10/596,922

Carlo Bacciottini

Office Action Summary	Application No. 10/596,922	Applicant(s) BACCIOTTINI, CARLO	
	Examiner JESSE PRAGER	Art Unit 3745

DETAILED ACTION

Figure F1: Mannava discloses the reference point and angle in between reference point and axial hole

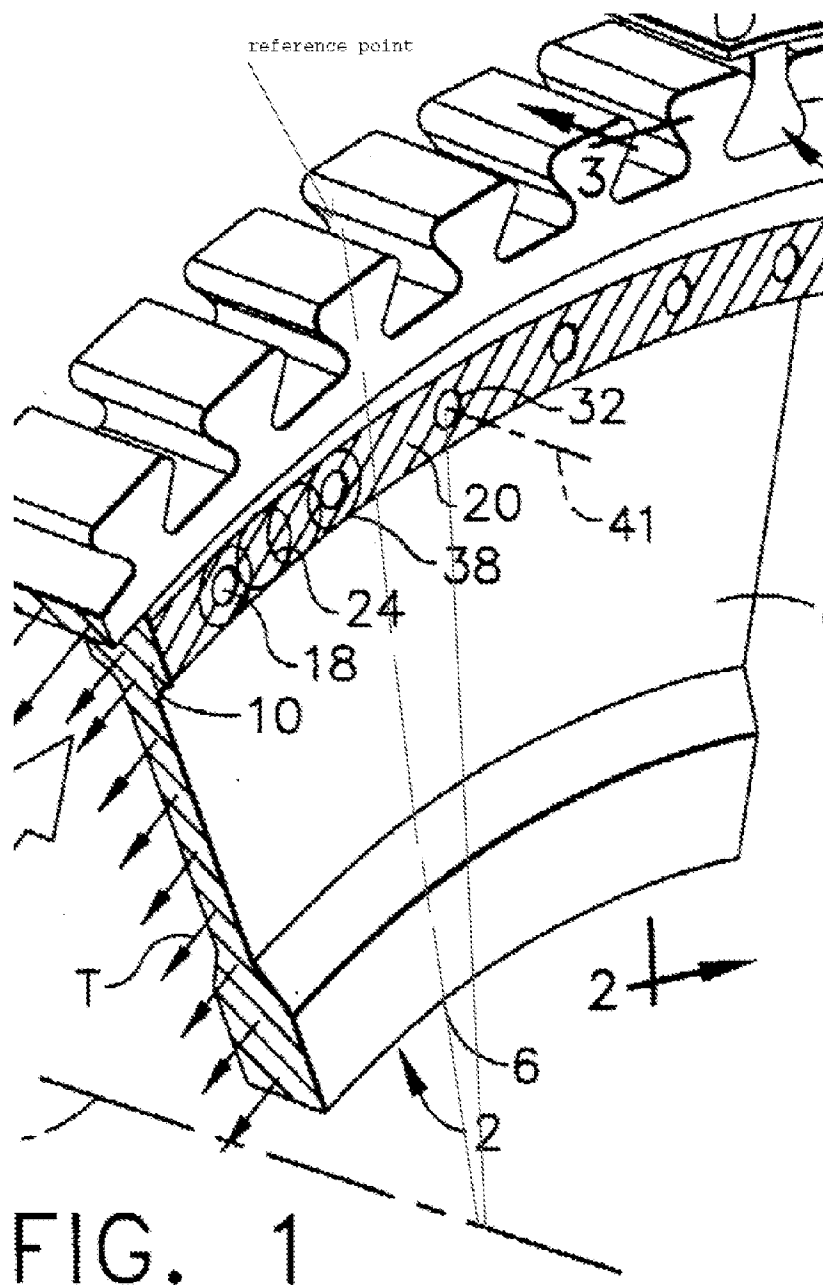
each slot has a reference point for placing a corresponding vane, an angle between the reference point of a slot and a central point of adjacent hole of the series of holes, and the reference point is defined by an intersection of (i) of an axis of the slot in a middle side section of the disk with (ii) an extension of a side surface of the outer portion (Fig. F1).

each slot has a reference point for placing a corresponding vane, an angle between the reference point of a slot and a central point of adjacent hole of the series of holes, and the reference point is defined by an intersection of (i) of an axis of the slot in a middle side section of the disk with (ii) an extension of a side surface of the outer portion (Fig. F1).
